**CITY OF SAN ANGELO**  
**BELL STREET PAVING, WATER AND WASTEWATER IMPROVEMENTS PHASE I**  
**SAN16188**

**ADDENDUM NO. 1**  
**July 27, 2017**

**00 91 13      ADDENDUM NUMBER 001**

## **PHASE 1 PRE-BID QUESTIONS RESPONSE LOG**

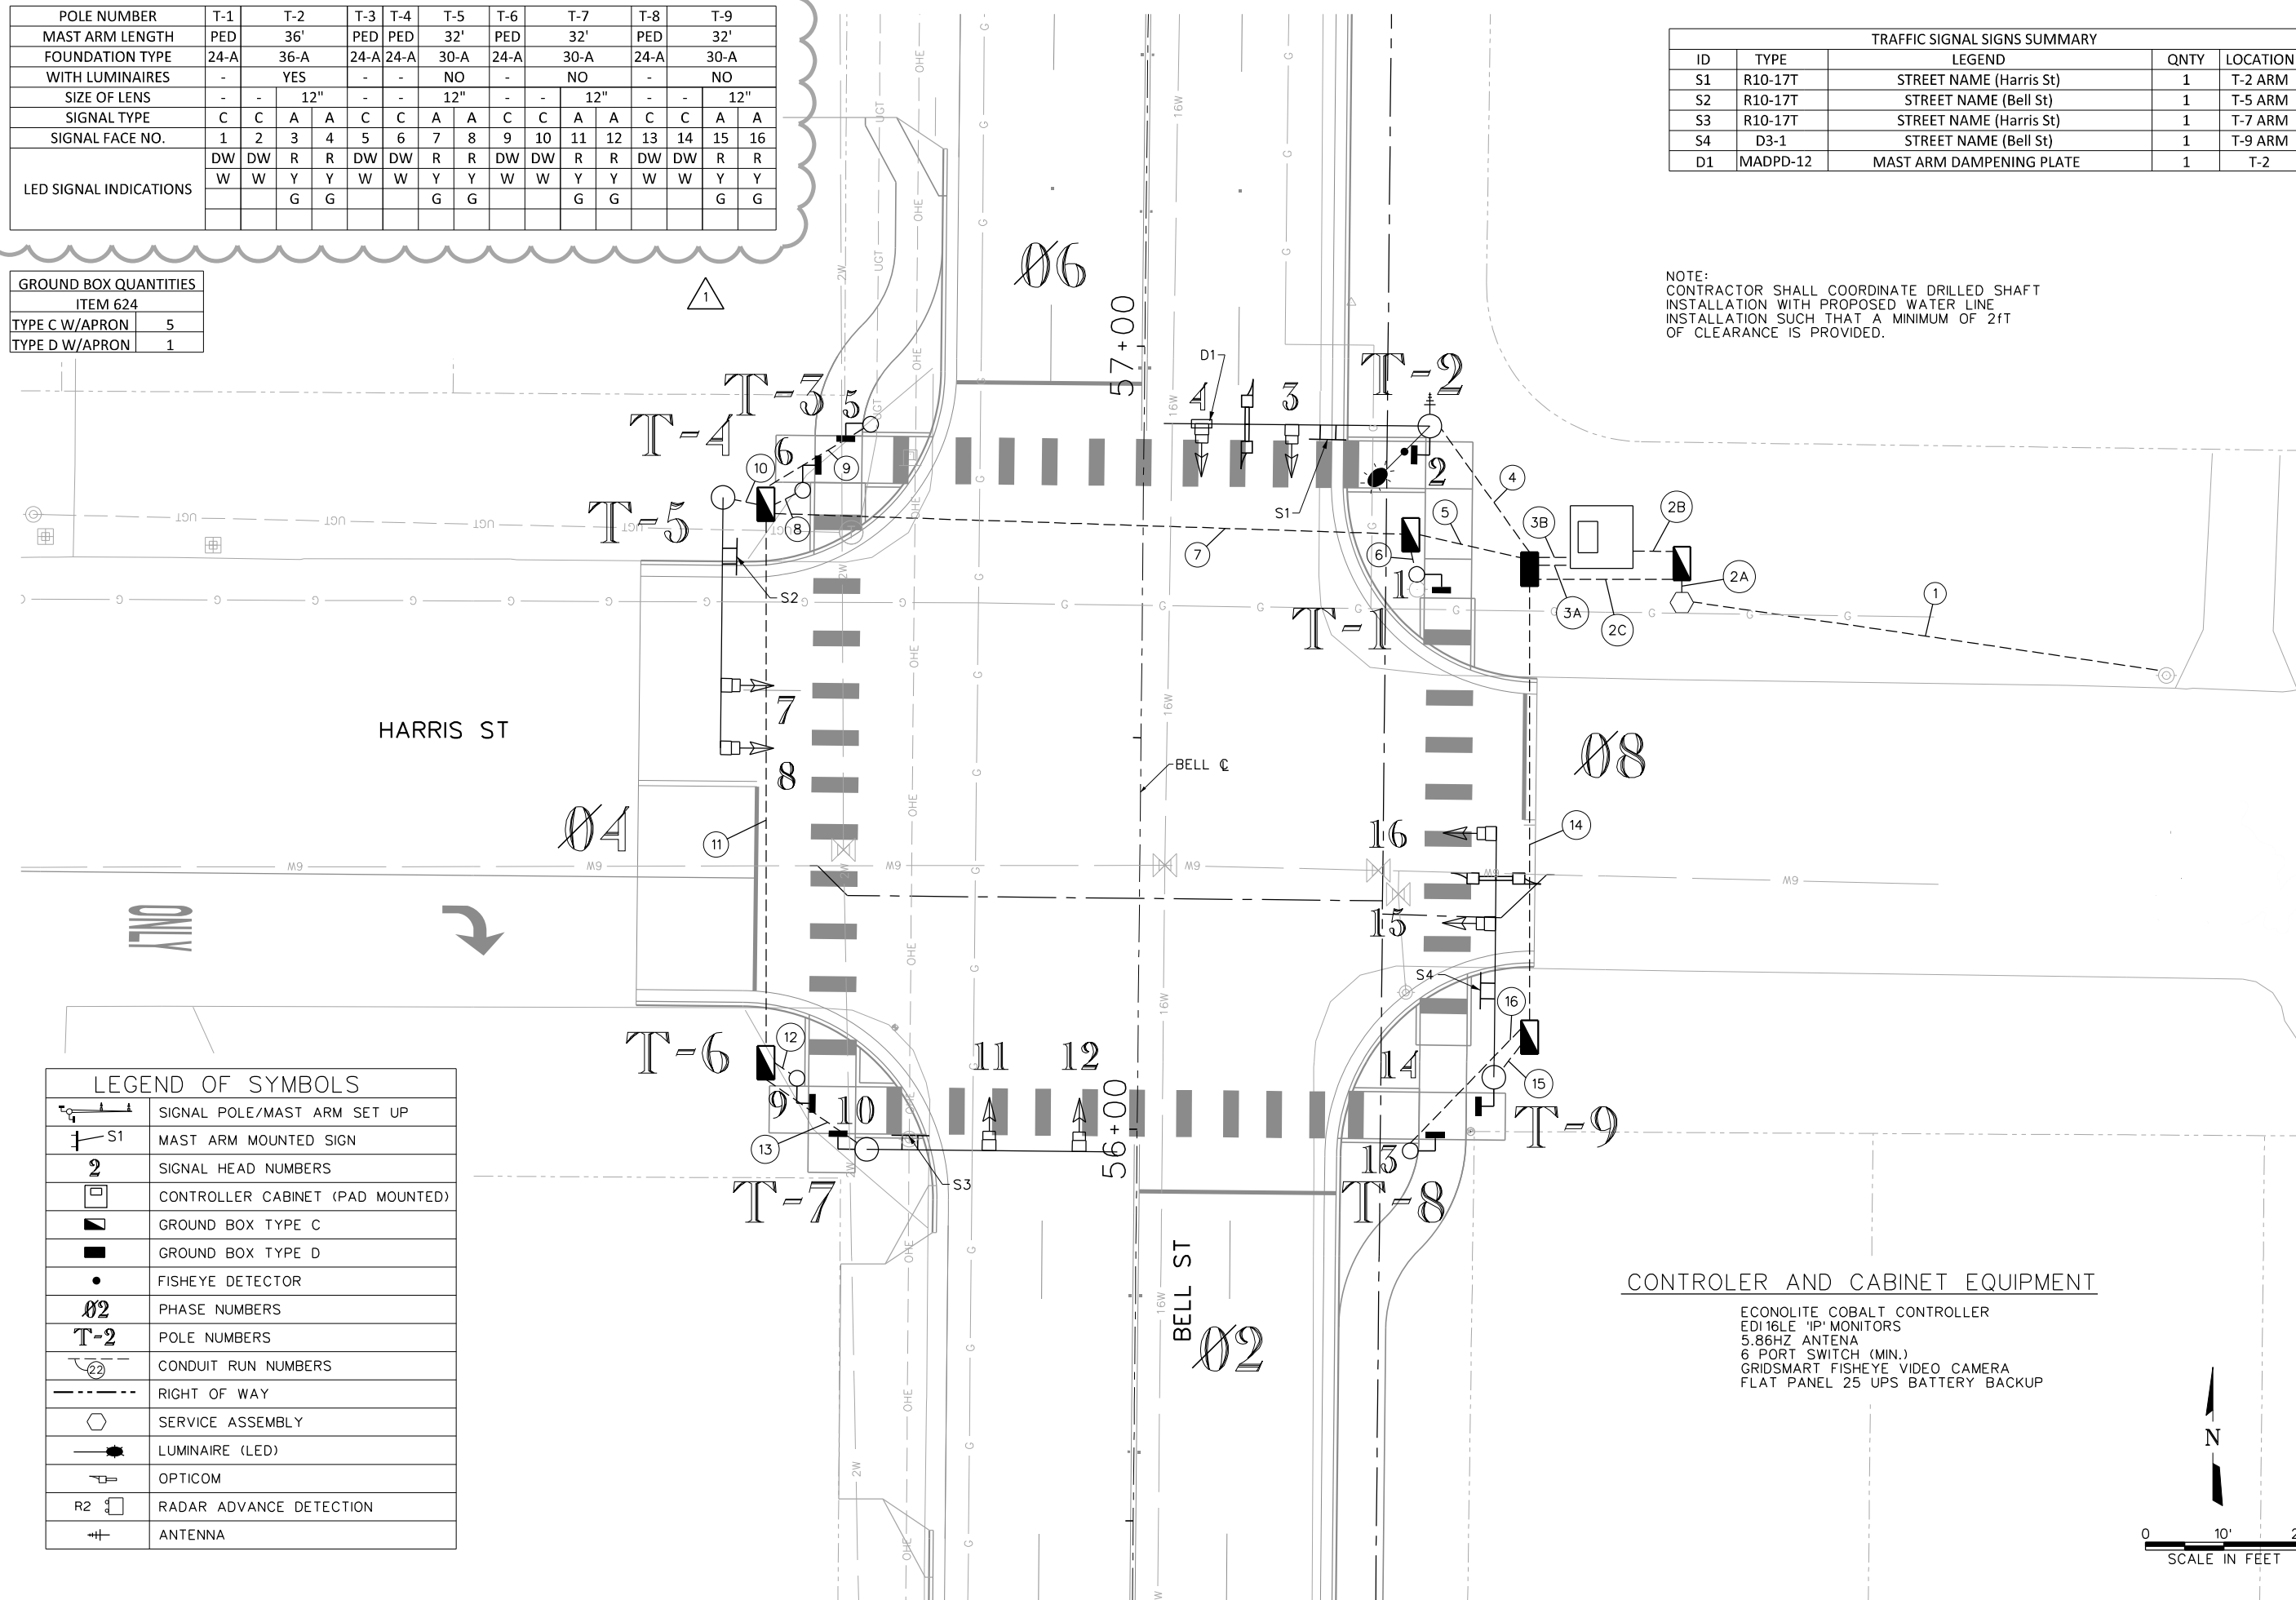
NUM.	QUESTION	RESPONSE	ACTION
31	On the geotechnical engineering study, there is no (tsf) numbers associated with the boring logs. It would be most helpful having that information for each boring log number.  Can you provide that information?	Shelby tubes were not obtained during the field investigation; therefore, we do not have those values.  It has been the experience of the City of San Angelo that subsurface rock has been previously encountered in surrounding areas. The Contractor shall include the potential cost of rock excavation in the unit costs for the bid items provided in the contract documents. No additional compensation will be provided for rock excavation.	Refer to Addendum 01, Item A1-1 F for clarification.
32	Plan markup revision received from a vendor by Purchasing Specialist Candice Baker Indicating the foundation size for 32' long mast arm poles should be changed from type 36-A to 30-A	The designer originally called for larger than the TxDOT minimum required foundation size for four(4) 32' long single mast arm assemblies. This was done to accommodate longer mast arms if needed in the future. After additional consideration, the City does not wish to bear the additional expense.	Refer to Addendum 01 Updated Drawings section. Plans have been revised to indicate minimum TxDOT standard foundation size. Four (4) foundations for 32' long mast arm assemblies have been changed from foundation Type 36-A to Type 30-A.

W-2

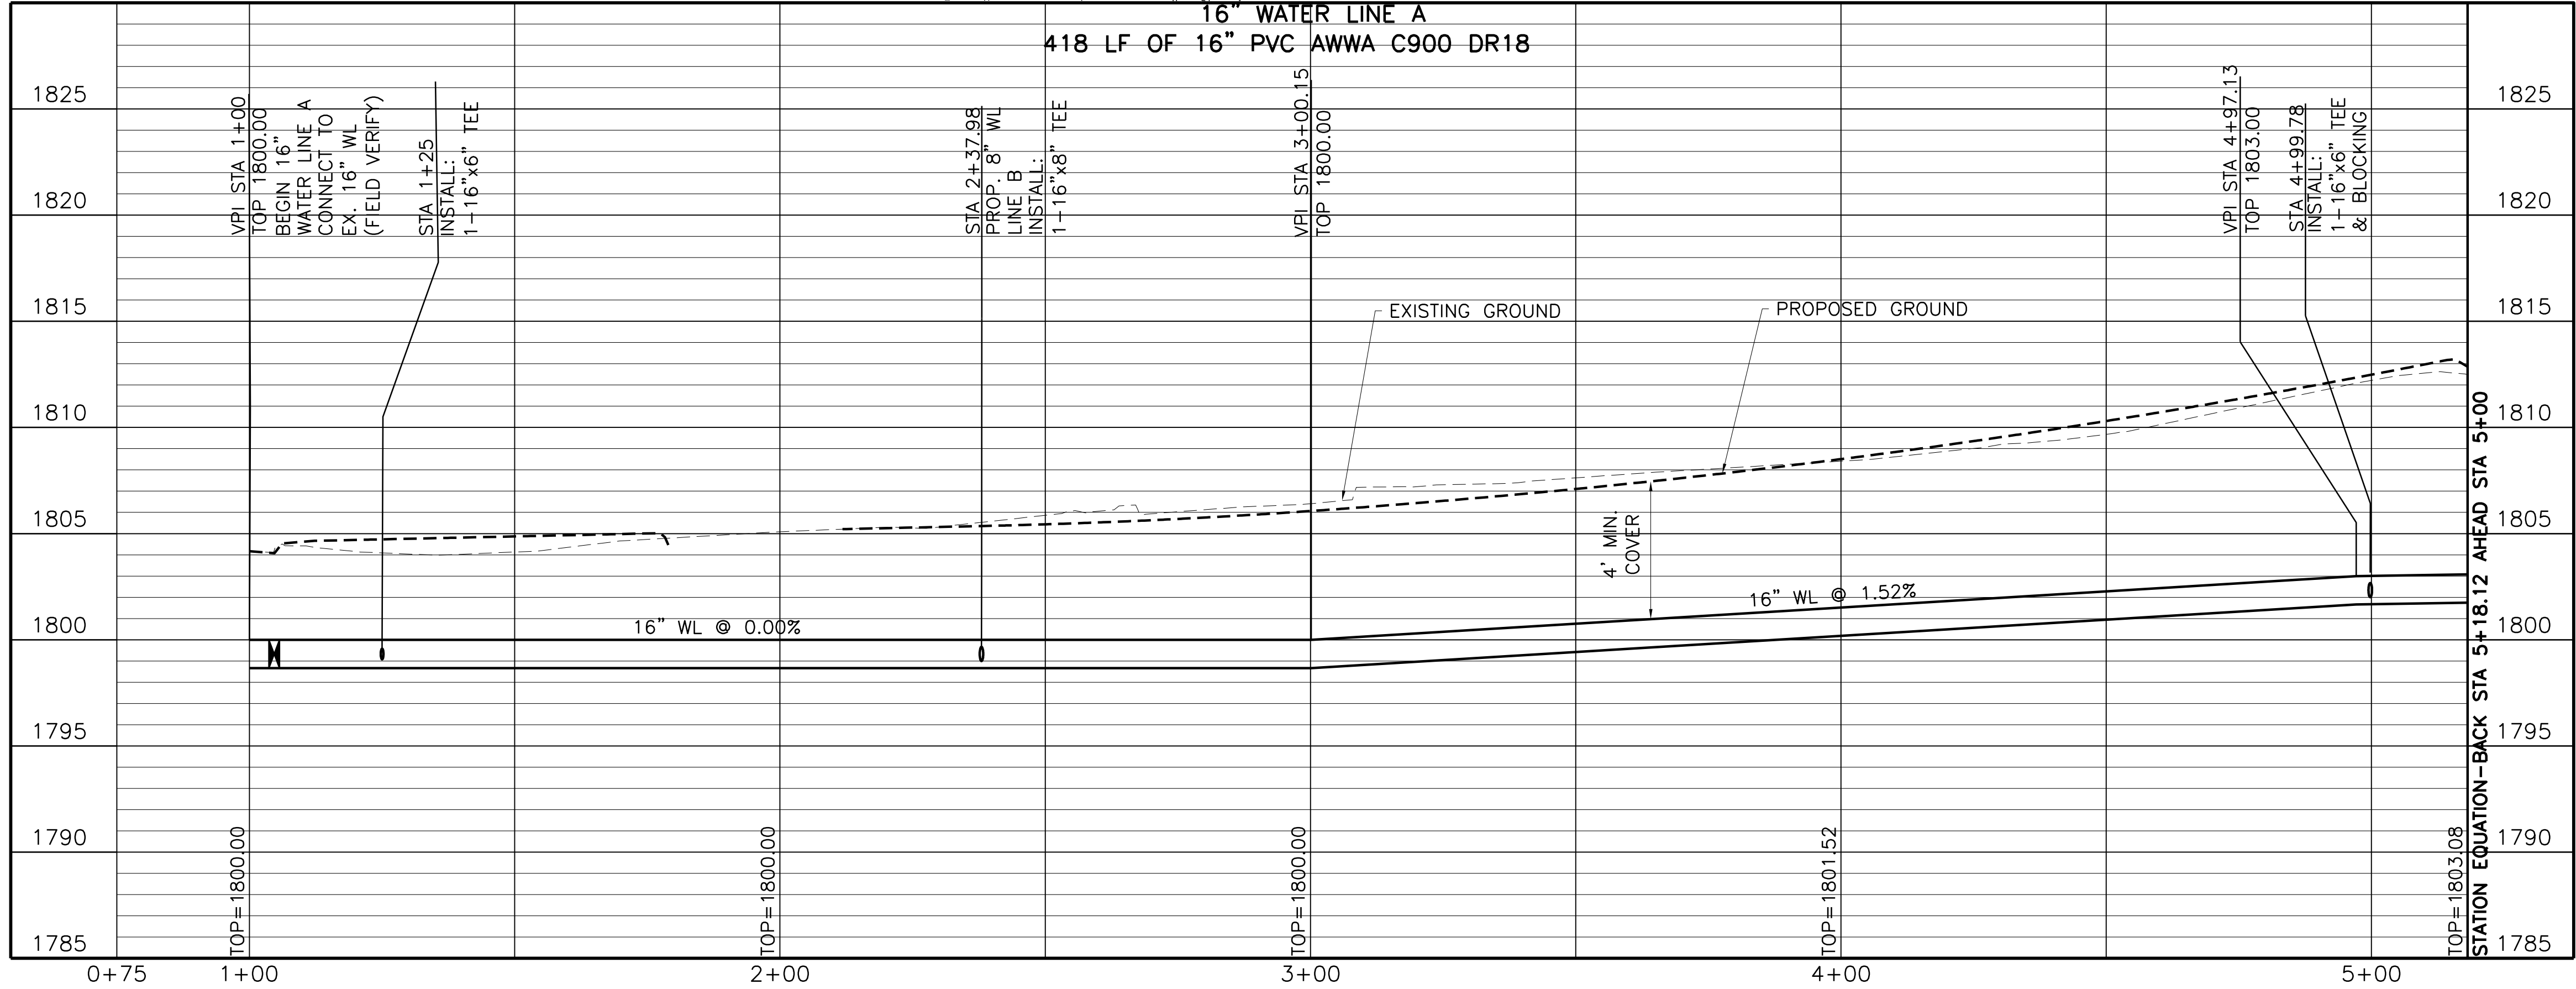
45	16" and 20" Inserta Valves are not compatible with Asbestos Cement Pipe	An alternative connection plan has been designed. If existing valve is determined to be functional near Sta 1+00, then linestop connection is not necessary.	Refer to Addendum 01, Updated Drawings, Sheets W-2, W-10 and W-11, which have been reissued to show the changes needed for the alternative connection plan.
46	we would like to purpose on plan sheet SS-2 we begin our by-pass pumping from existing man-hole to the upstream west man-hole. We would then install the new man-hole at sta 1+00 lay up to sta.1+65 Add a 12x12 y to pick up the existing 12inch line after we lay up to about sta .1+65 we would install an additional man-hole test the section and then tie existing 12in. sewer back into new line. This will drastically reduce the cost of continuously running by-pass pumps. Once the whole line is installed we Would come back install plug in 12inch y and concrete this plug in place.	The bypass plan should meet the requirements of the updated Specification 4.29 and will be approved as part of the formal submittal process during construction.	None. The contractor's brief explanation of his approach sounds logical but shall not be evaluated during the advertisement phase.  Refer to Addendum 01, Updated Technical Specifications, Specification 4.29 for requirements.

- NOTES:
- EXISTING 16" WATER LINE EAST OF BELL STREET AND ALONG RIO CONCHO MAY BE ASBESTOS CEMENT PIPE. PRIOR TO CONNECTIONS OR DISTURBING EXISTING WATER LINE IN THIS AREA CONTRACTOR SHALL TEST WATER LINE FOR ASBESTOS AND IF TEST IS POSITIVE, THE CONTRACTOR SHALL COORDINATE WITH OWNER.
  - 6" STUBOUT FOR PARK SERVICE SHALL HAVE A MINIMUM COVER OF 4'.
  - LINE STOP AND PLUG SHALL BE INSTALLED AFTER PROPOSED 16" WATER LINE A HAS BEEN BROUGHT INTO SERVICE TO INCLUDE ASSOCIATED DISTRIBUTION LINE CONNECTION.
  - IF IN-LINE VALVES ARE FUNCTIONAL, LINE STOP WILL NOT BE REQUIRED.
